[Docket No. FAA–2010–1101; Directorate Identifier 2009–CE–013–AD; Amendment 39–16690; AD 2011–10–09]

Airworthiness Directives; Cessna Aircraft Company Models 150, 152, 170, 172, 175, 177, 180, 182, 185, 188, 190, 195, 206, 207, 210, T303, 336, and 337 Airplanes

ACTION: Final rule.

Figure 1. Diameter of seat pin locking engagement hole

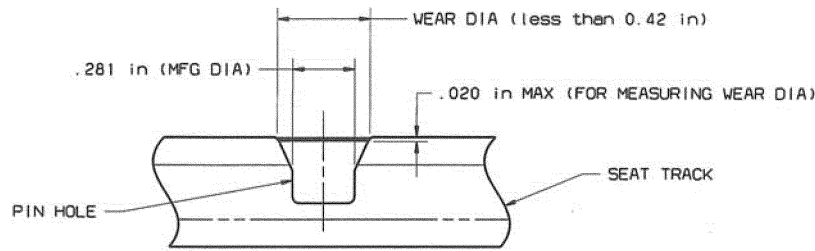
Dave McFarlane requested we add a maximum allowable incremental 0.07-inch radius dimension to figure 1 at the outside diameter dimensions for clarification.

We disagree with this comment. The measurement dimensions in figure 1 adequately address the measurements necessary for this AD. Additional measurements will not provide any additional benefit.

Figure 4. Closeup of seat roller housing and tang gap width

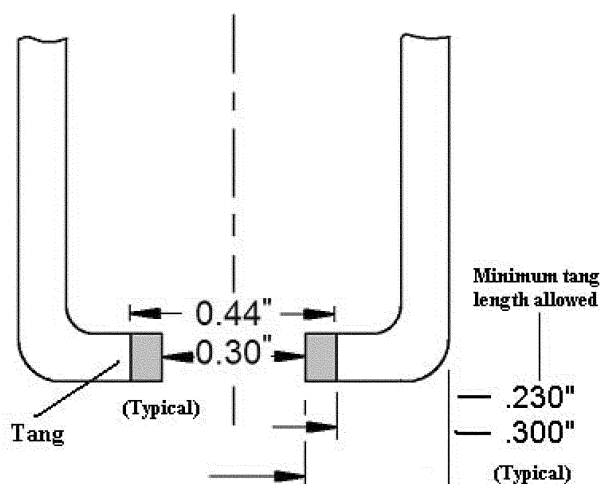
Brian A. Andrus, Jim Currie, and Jerry Unruh requested we change the tang measurement to the outside of the seat roller housing and change the description of the tang measurement. This change would make it easier for the inspector to take the measurement and to better understand what is being measured.

We agree with this comment. We agree that measuring the tang length inside of the roller housing is difficult because of the presence of the rollers inside of the roller housing.

We have changed the callouts in figure 4 to measure the tang length from outside of the roller housing instead of from inside of the roller housing. We have also changed the description of the tang measurement in figure 4 to more accurately describe the measurement.
